Grimes City Council Agenda

Grimes City Council Meeting June 22, 2021 In Person/Zoom at Grimes Community Center, 410 SE Main Street

- E. Crossroads Plat 4, Preliminary Plat
- F. Crossroads Plat 4 Site Plan
- G. Report and Status Update on Water Distribution

DETAIL 'E'

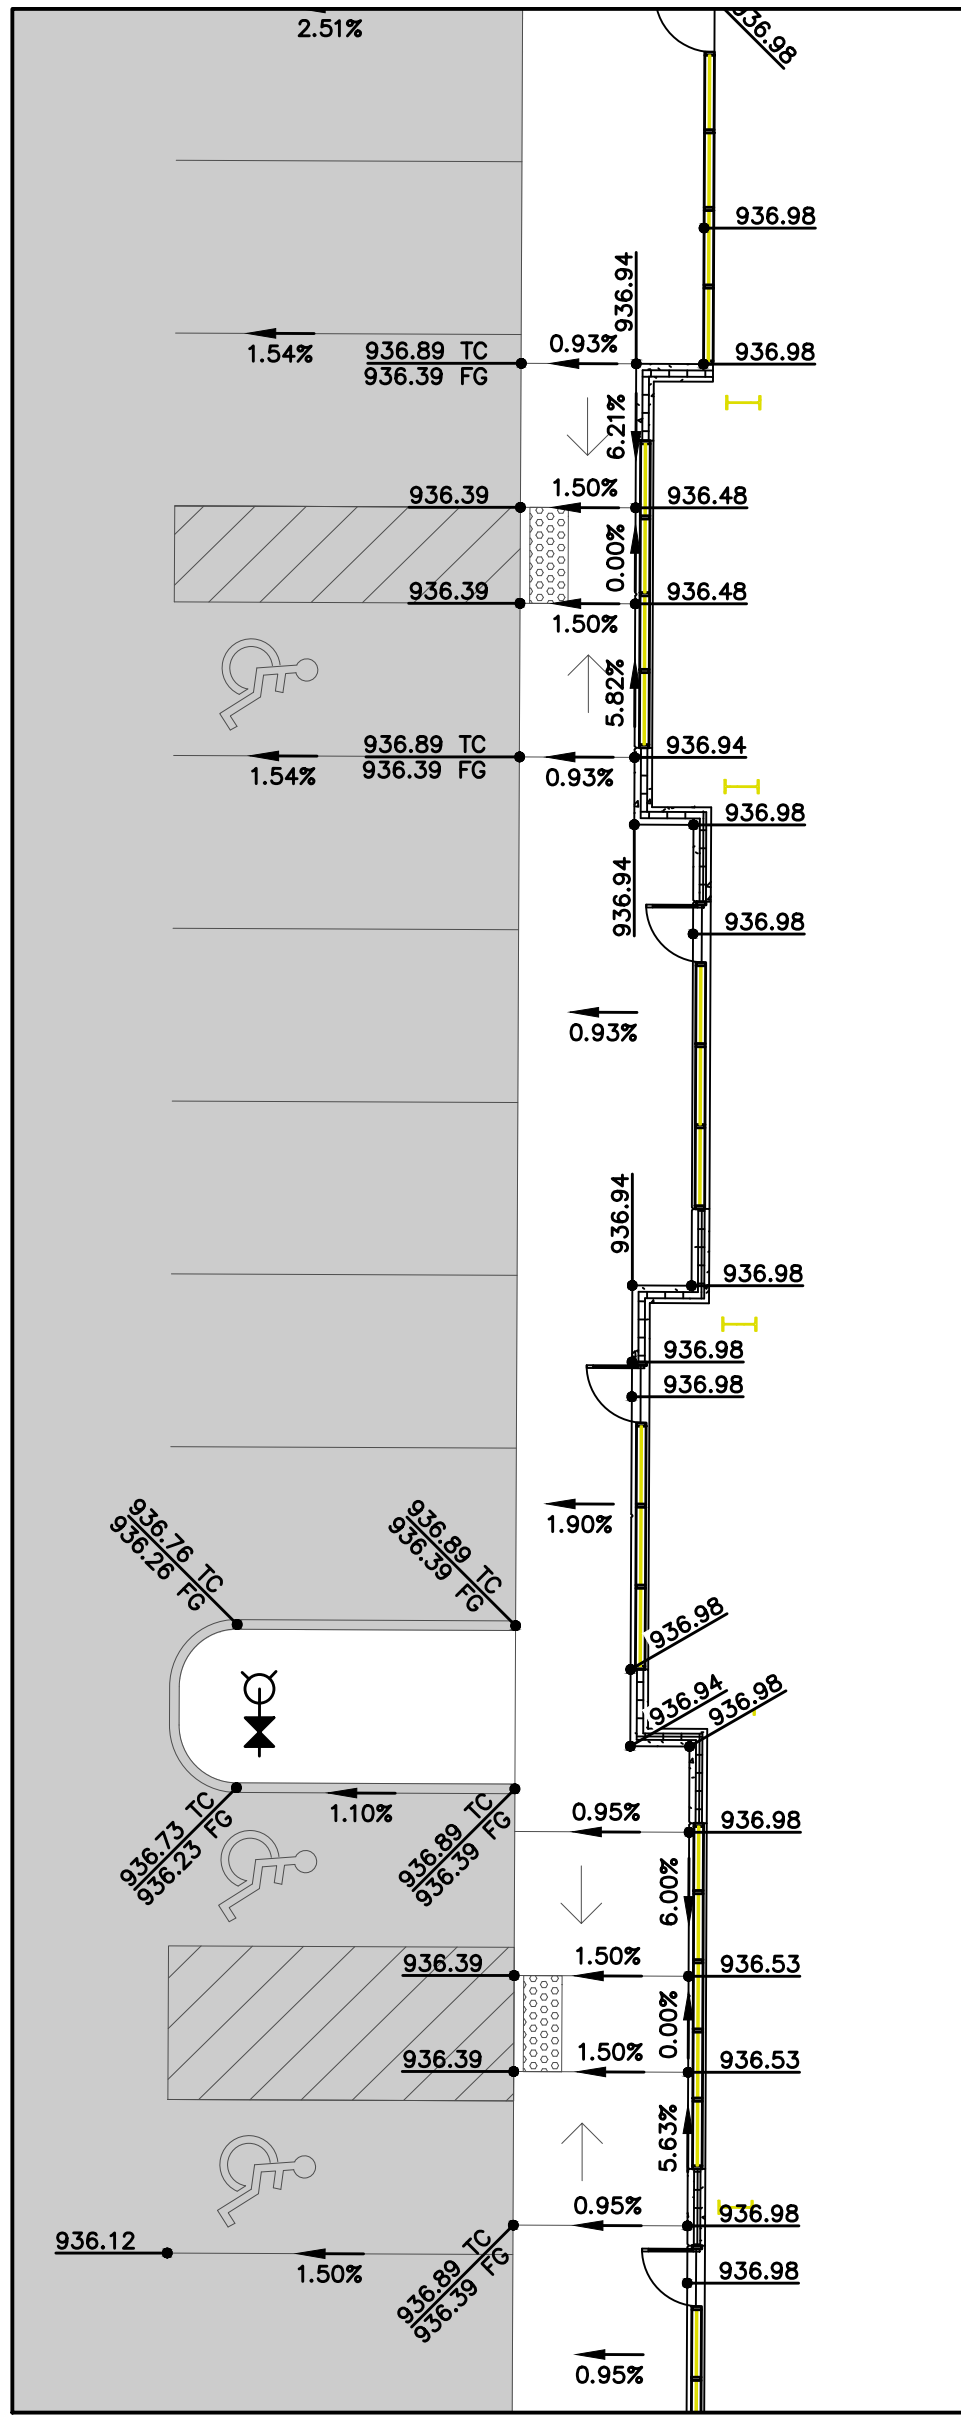
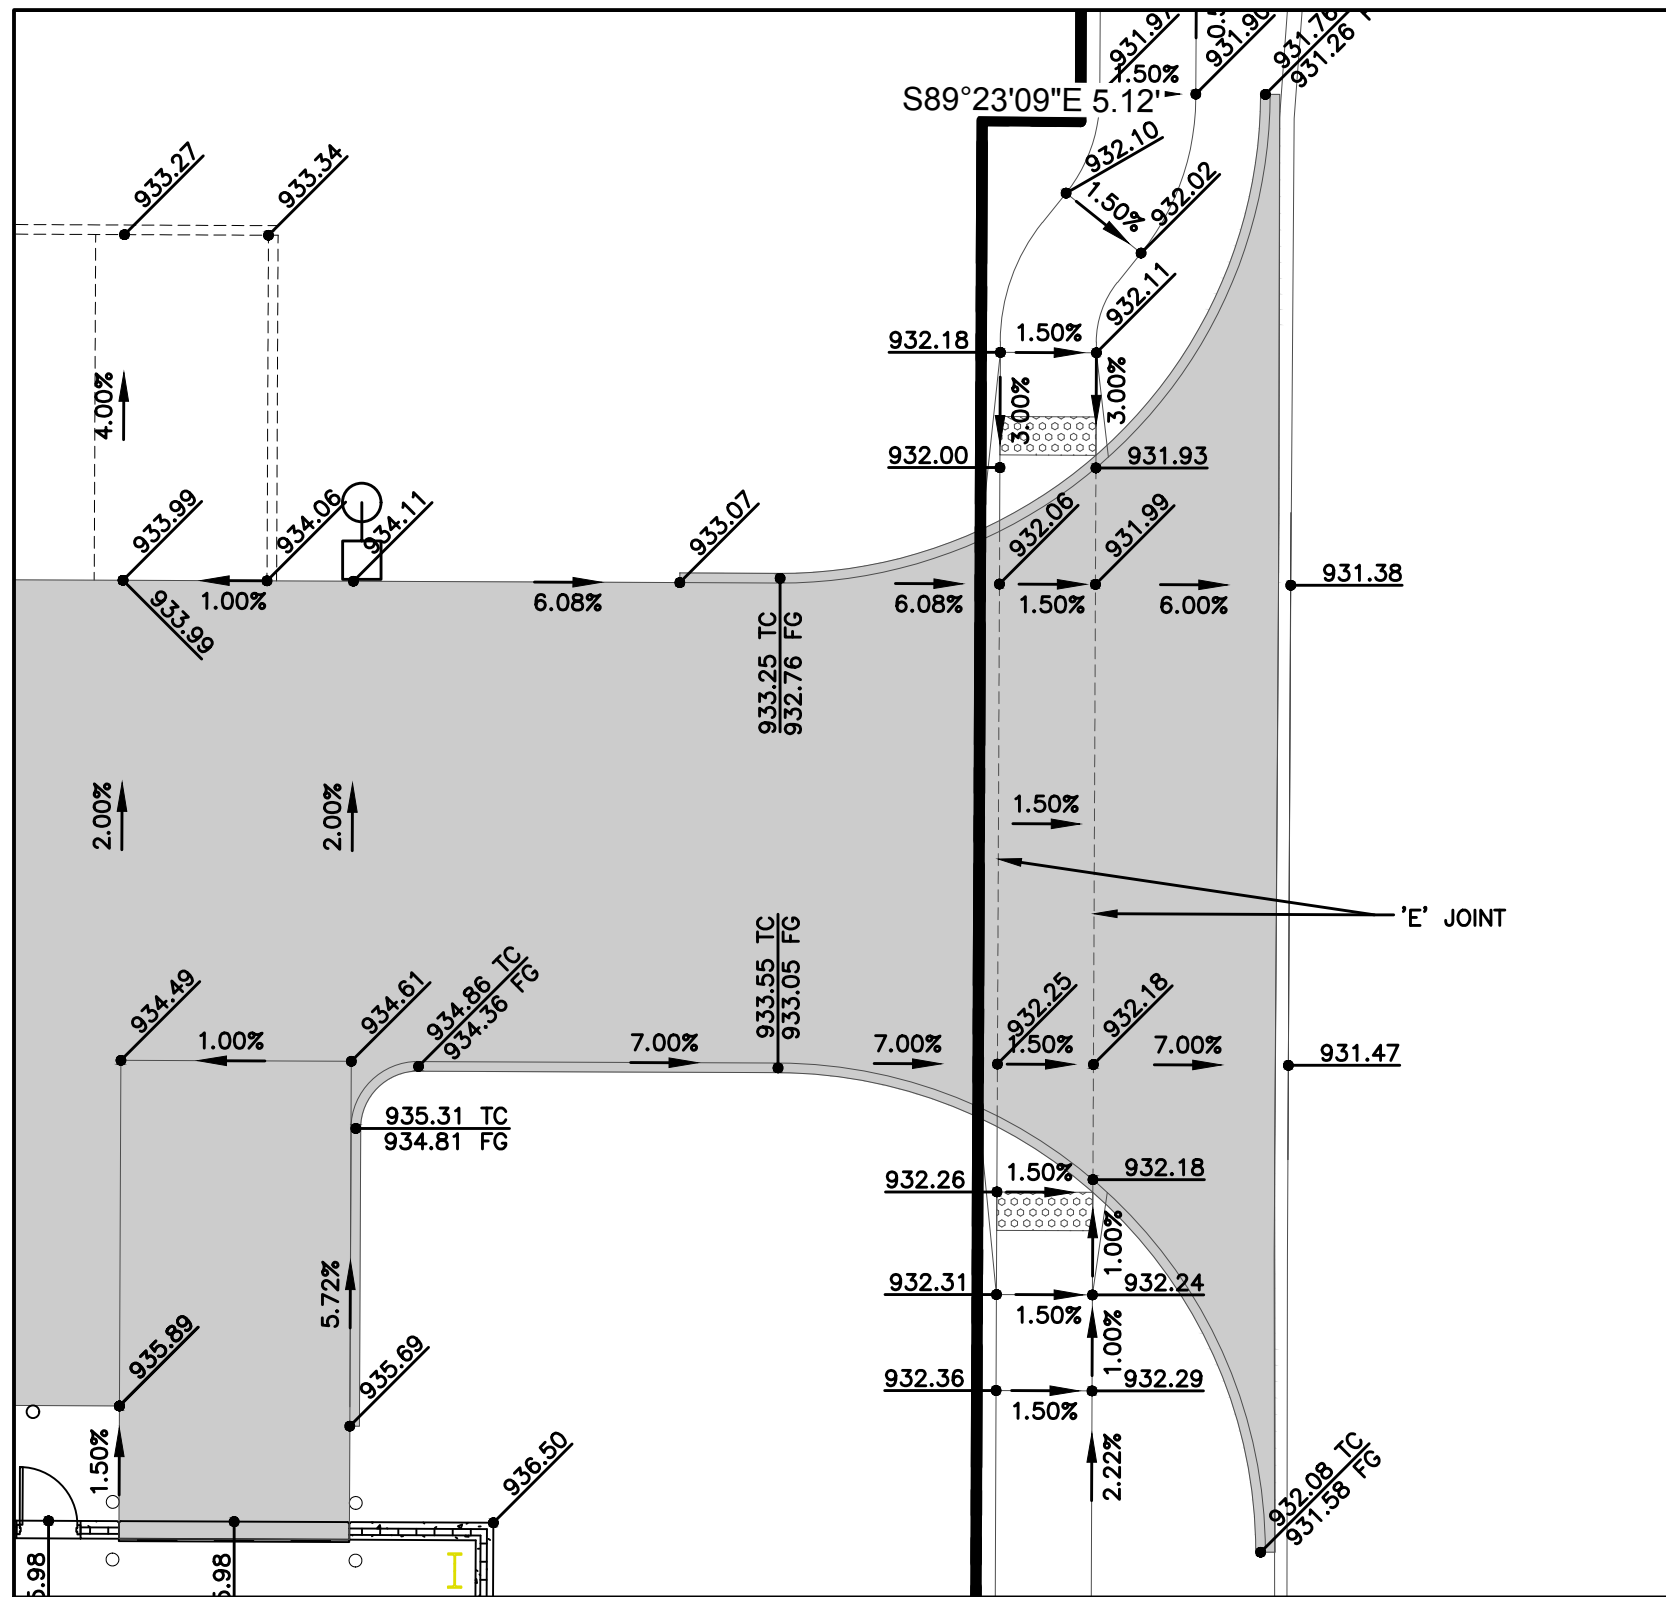
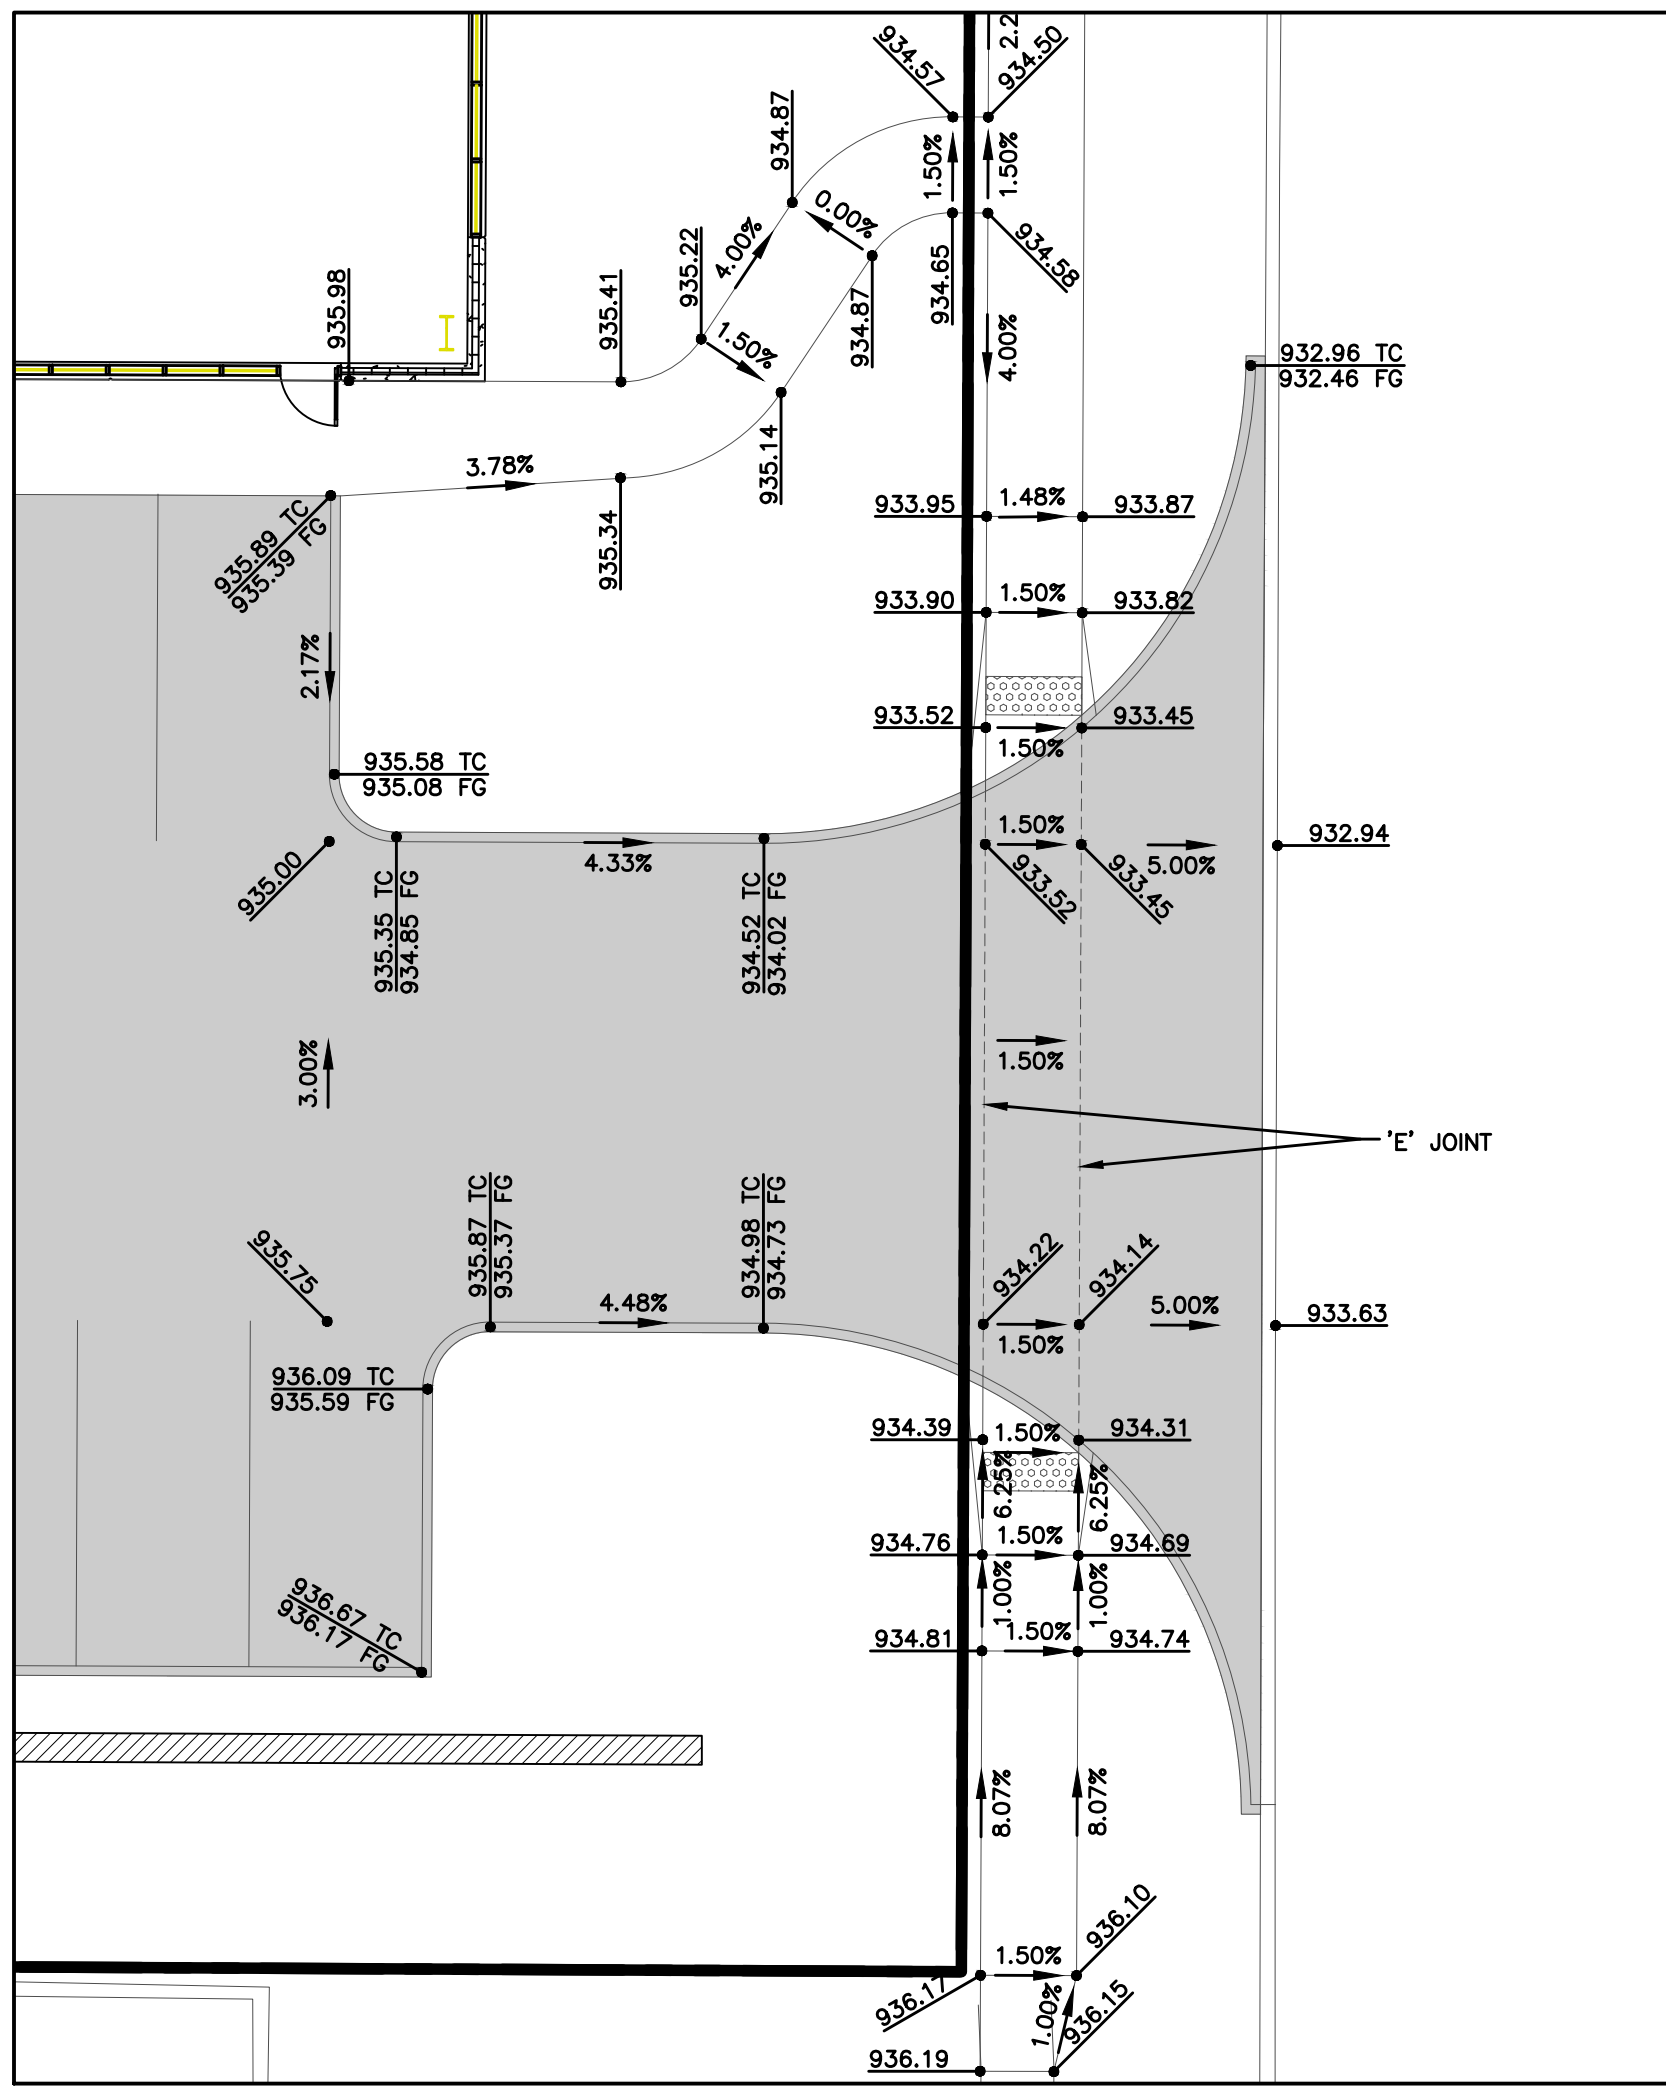
- ~~1. C5.0: Provide emergency overflow and protection on basin.~~
- ~~2. C7.0: Provide detail for ST-2 and perforated riser.~~
- ~~3. C7.0: Do buildings require roof drain connections?~~
- ~~4. C7.0: How will the DA going to the future parking expansion be captured?~~
5. C5.0 & C9.1: Label basin as bioretention pond and provide cross-sectional detail of basin layers.
